<b>LOCAL HISTORIC DISTRICT:</b>	Wilmore
<b>PROPERTY ADDRESS:</b>	1508/1510 South Mint Street
<b>SUMMARY OF REQUEST:</b>	Fenestration changes, signage, dormer addition, site features, tree removal
<b>APPLICANT:</b>	Bruce Gaiser (Robert and Joan Rash, Owner)

# Charlotte Historic District Commission - Case 2015-214

October 7, 2015

SITE PLAN - REVISED  
 SCALE: 1" = 20'-0"  
 0 5 10 15 20 25  
 GRAPHIC SCALE IN FEET

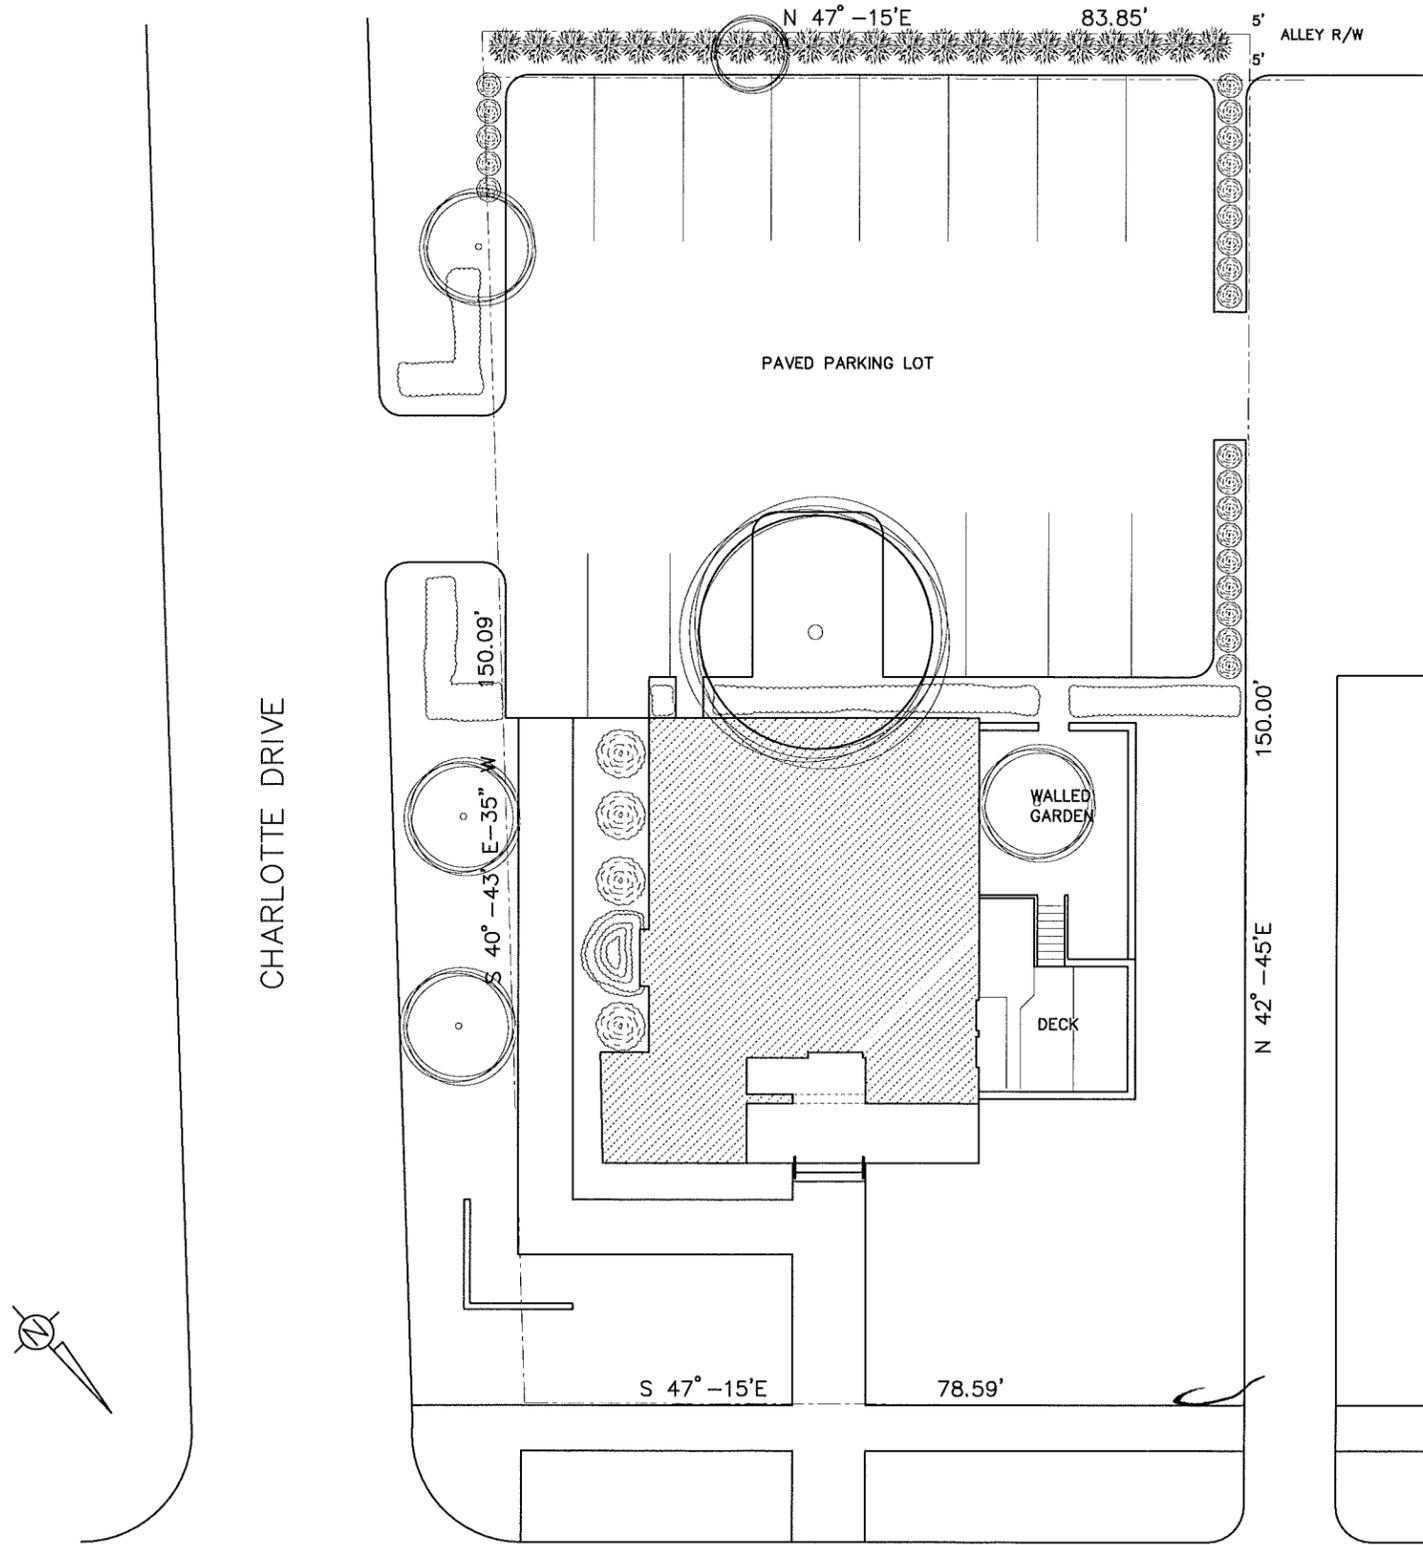
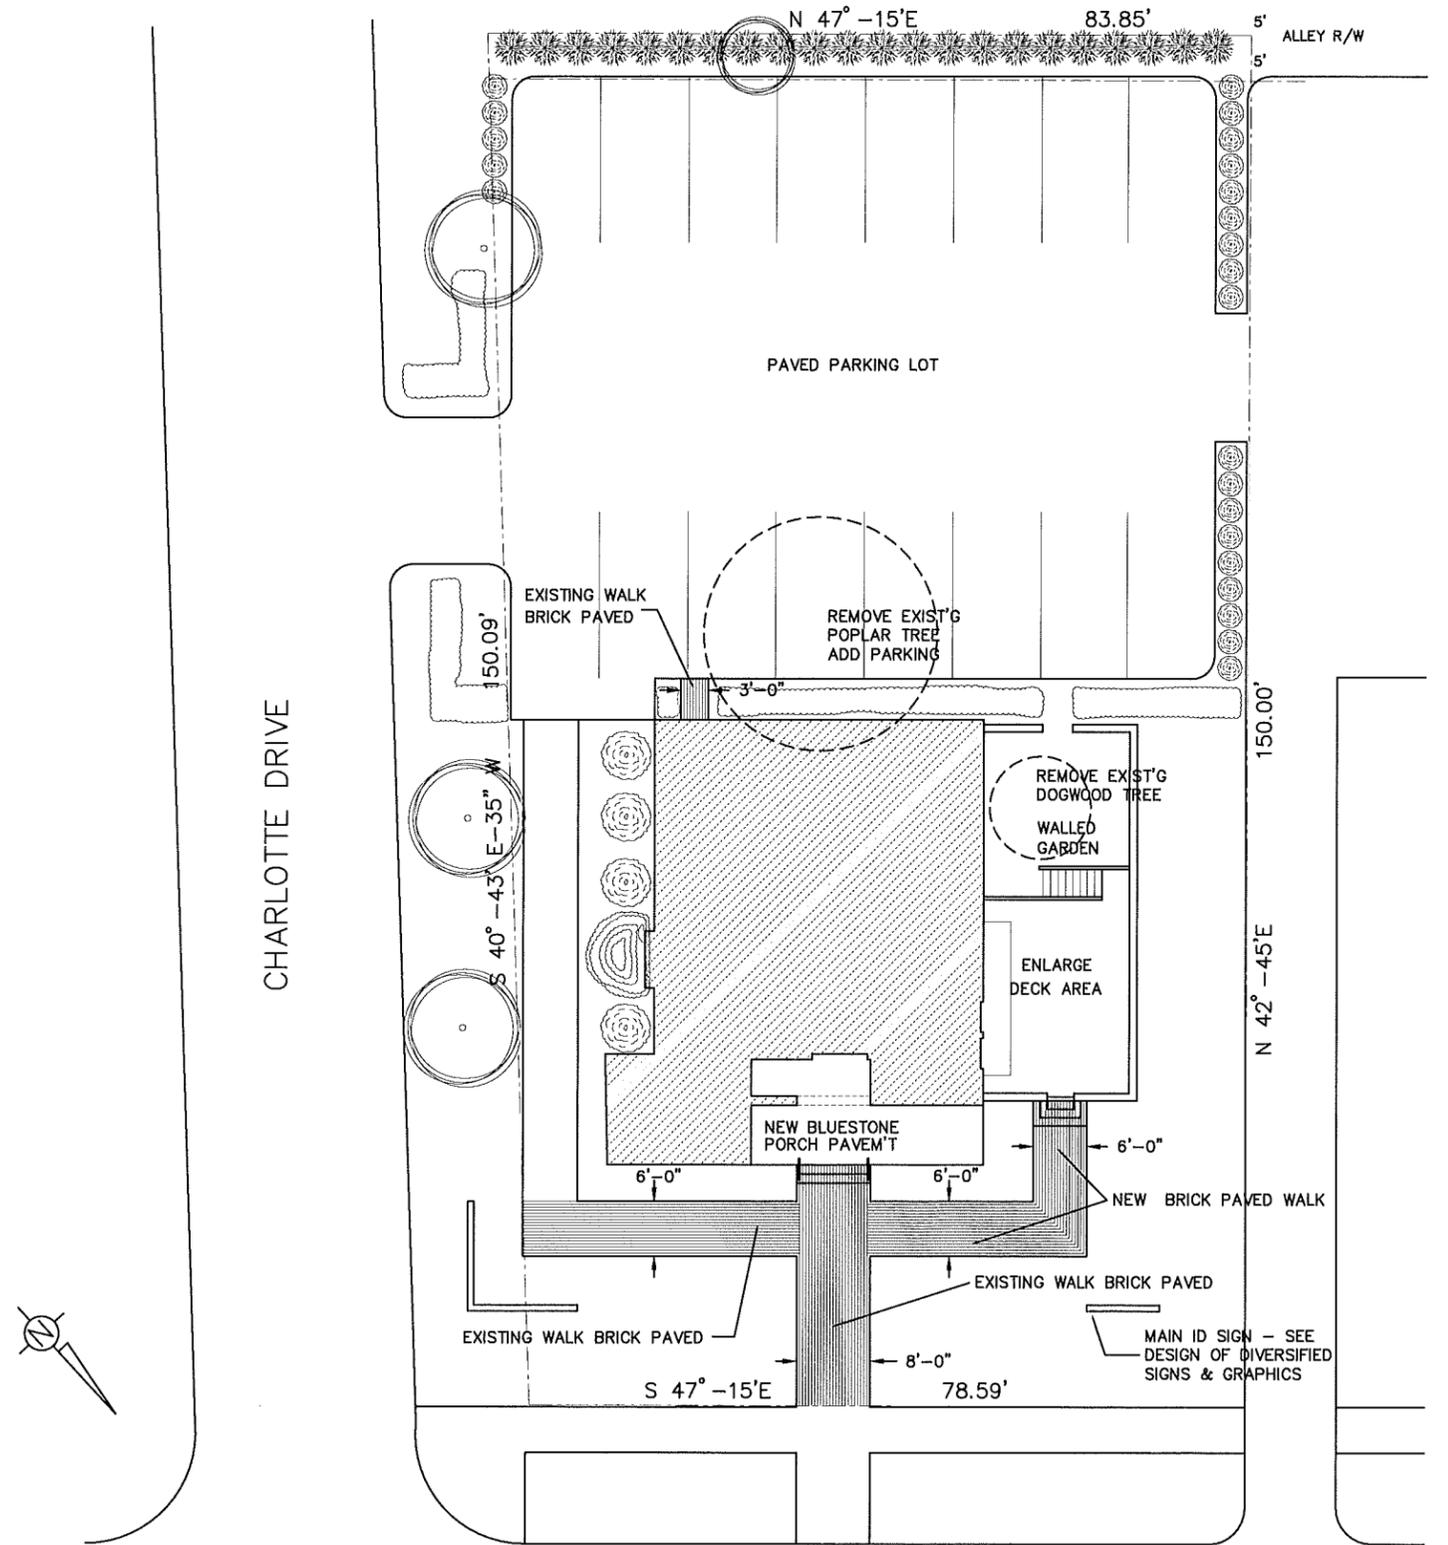
The proposal is a group of changes to the façade and site work. Front façade changes include the addition of shutters, removal of an existing window opening, addition of a hipped dormer on the front below the ridge, extension of a brick wall on the right side and new arched entrance. Changes to the right side include a new door and deck expansion. Changes to the left elevation are a new sign and windows. Site work includes the removal of a mature tree in the rear yard, brick sidewalk and bluestone porch decking. The applicant is requesting cementitious siding on the new gable.

FRONT ELEVATION — REVISED

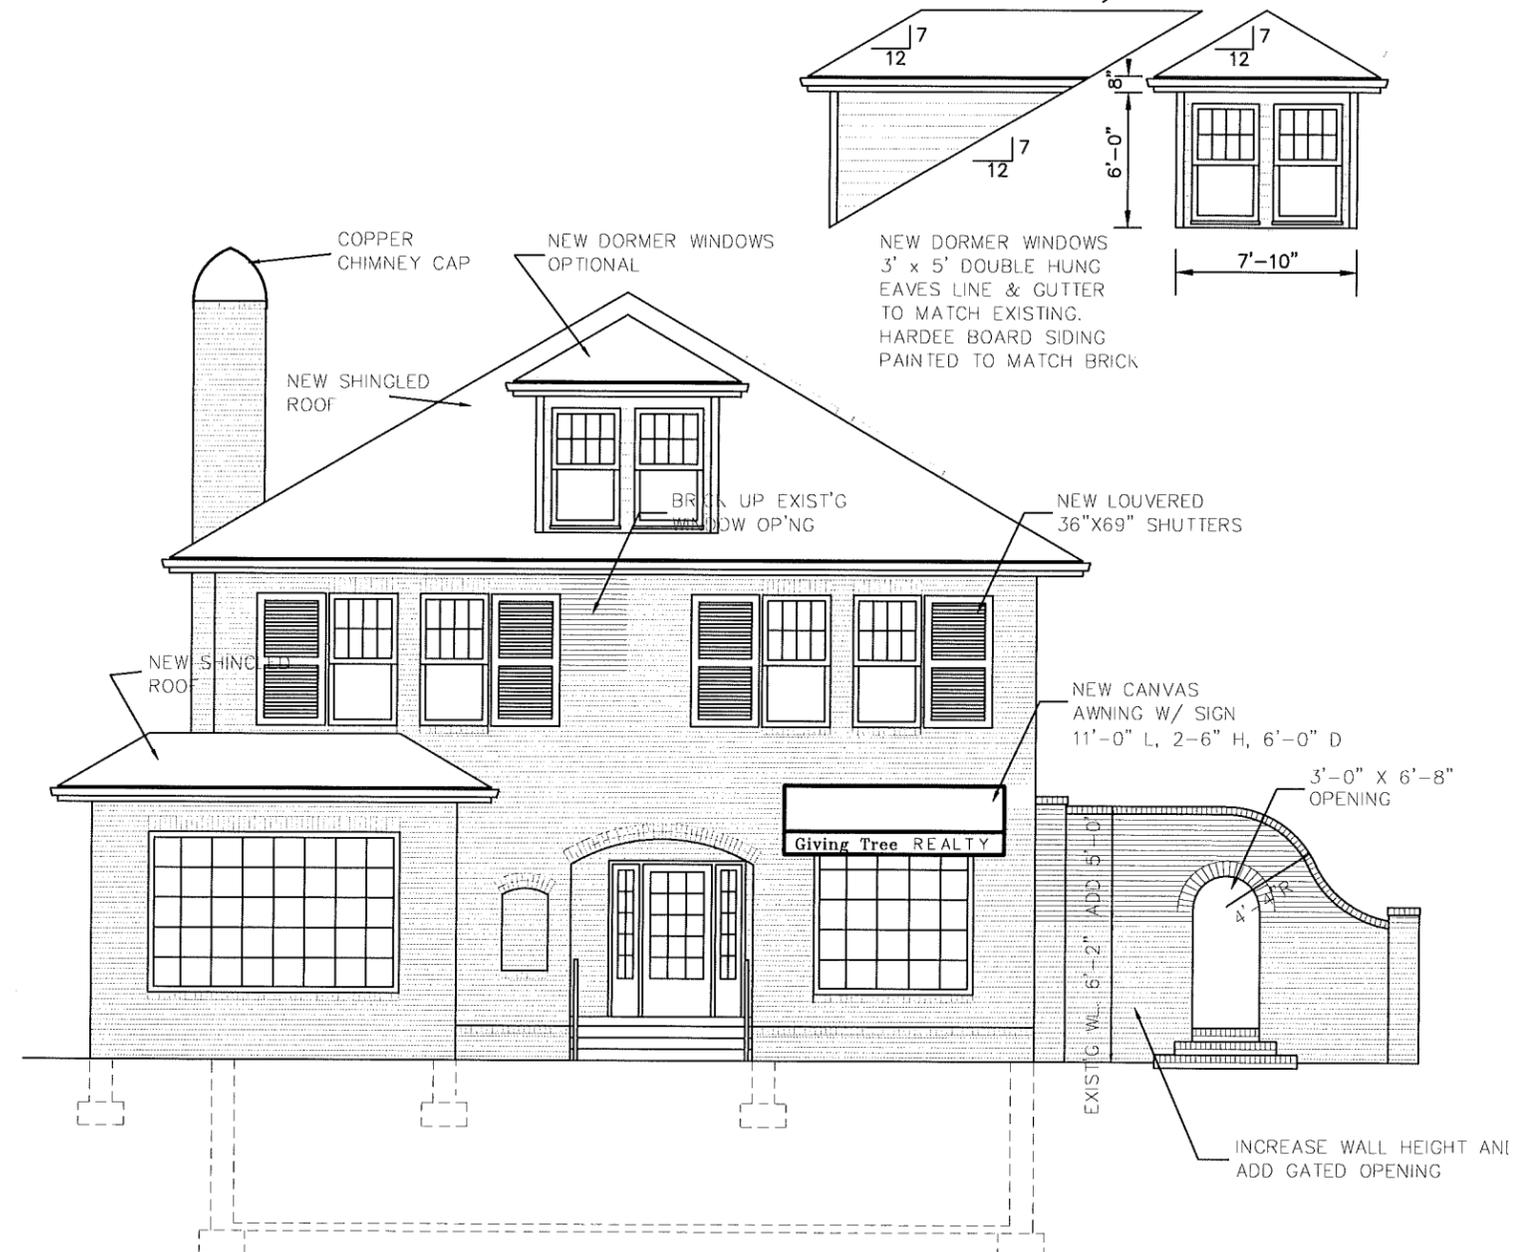
The HDC will determine if the proposal meets the guidelines for Fenestration, Rhythm, Materials and Context.
